## Product Update: Front Balancer Shaft Oil Seal (Supersedes 00-073, dated October 6, 2000)

Install an oil seal retainer to keep the oil seal from backing out.

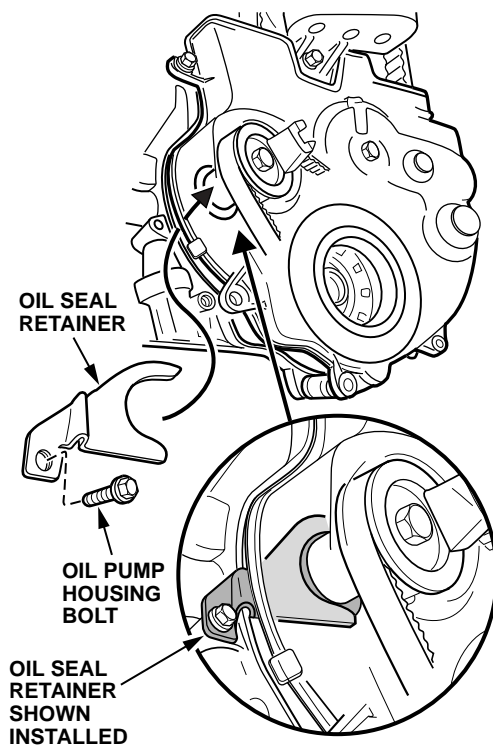
- Remove the oil pump housing bolt to the left and below the front balancer shaft.

- Install the oil seal retainer from the kit on the pump housing with the bolt you just removed. Torque the bolt to 12 N·m (8.7 lb-ft).
